CITY OF GLENDALE, CA

DESIGN REVIEW STAFF REPORT – SINGLE FAMILY

October 28, 2021 <i>Decision Date</i>	1271 Oak Circle Drive, Glendale, CA 91208 <i>Address</i>
Administrative Design Review (ADR) <i>Review Type</i>	5611-014-051 <i>APN</i>
PDR 2111853 <i>Case Number</i>	Nareg Khodadadi <i>Applicant</i>
Vista Ezzati, Planner <i>Case Planner</i>	Rodrick P. Safarian & Gohar Palanjian <i>Owner</i>

The applicant is proposing a 630 square-foot addition to the first floor and the conversion of existing attic space into a 650 square-foot second-floor addition to an existing one-story, 1,513 square-foot single-family residence (originally constructed in 1948) on a 7,578 square-foot interior lot located in the R1 (FAR District II) Zone. The overall height and roofline of the house will remain unchanged.

PROPOSED SITE PLAN
SCALE : 1/8" = 1'-0"

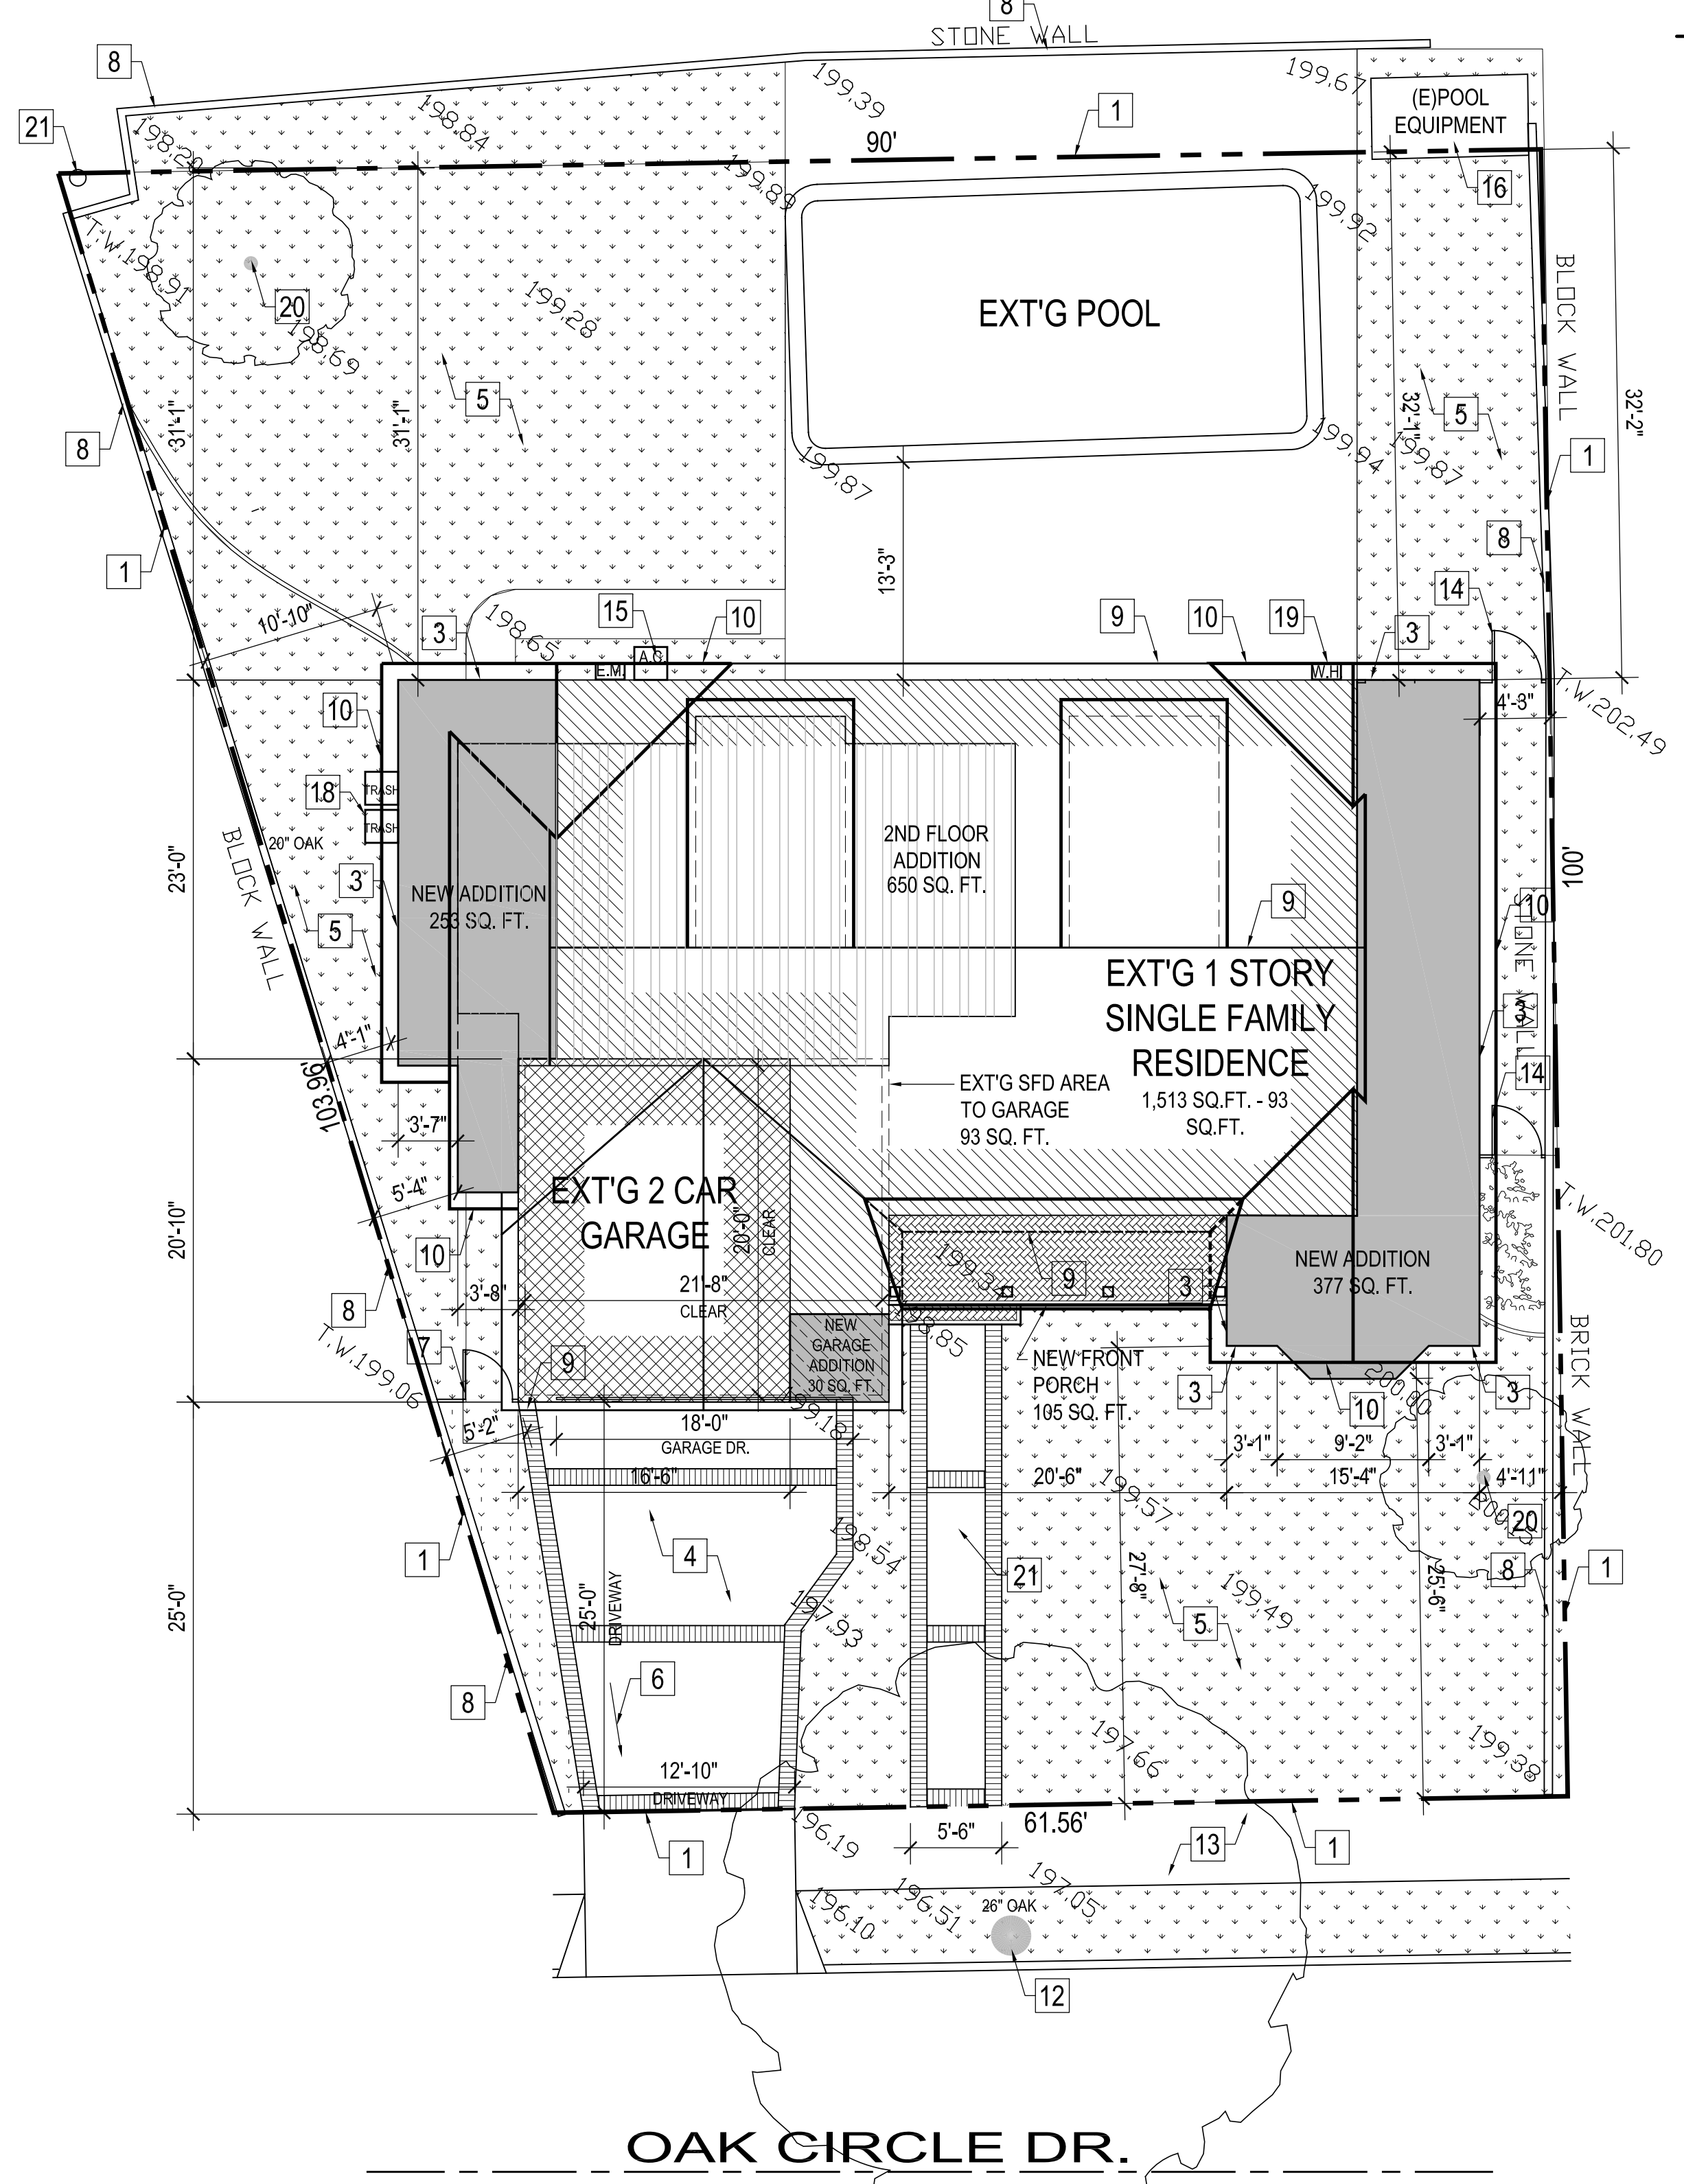
The drawings identify a new gate along the easterly property line, and is appropriately located. No other information is provided regarding the height or the design and staff is recommending a condition of approval that the applicant submit a detail of the gate design for staff review and approval.

- The existing landscape is to be maintained. There is one oak tree located on-site and one oak tree located in the parkway. The on-site tree is proposed for removal. The applicant has submitted an Indigenous Tree Report (Attachment 6), and the City's Urban Forestry Department has reviewed the application and did not cite any major concerns with the proposal. A staff recommended condition of approval requires the applicant to comply with the Urban Forestry Department Comments,

Project, as proposed, appears to be supportable by Forestry, on the condition the applicant submits a landscaping plan showing the two new coast live oak trees on site surrounded by oak woodland-compatible planting and wood chips for ground cover and the City of Glendale Street Tree in the adjacent parkway is protected throughout construction.

1. The applicant shall comply with all of the recommendations identified in the Urban Forestry Department Comments dated August 2, 2021.
2. The drawings shall be revised to include details of the gate design.
3. The drawings shall be revised to identify exterior light fixtures.

1. The applicant submits a landscape plan that shows the two new coast live oak trees on site surrounded by oak woodland-compatible planting and wood chips for ground cover.
2. The applicant applies for an Indigenous Tree Permit for the removal of the tree at the time that the project is approved by Building and Safety.
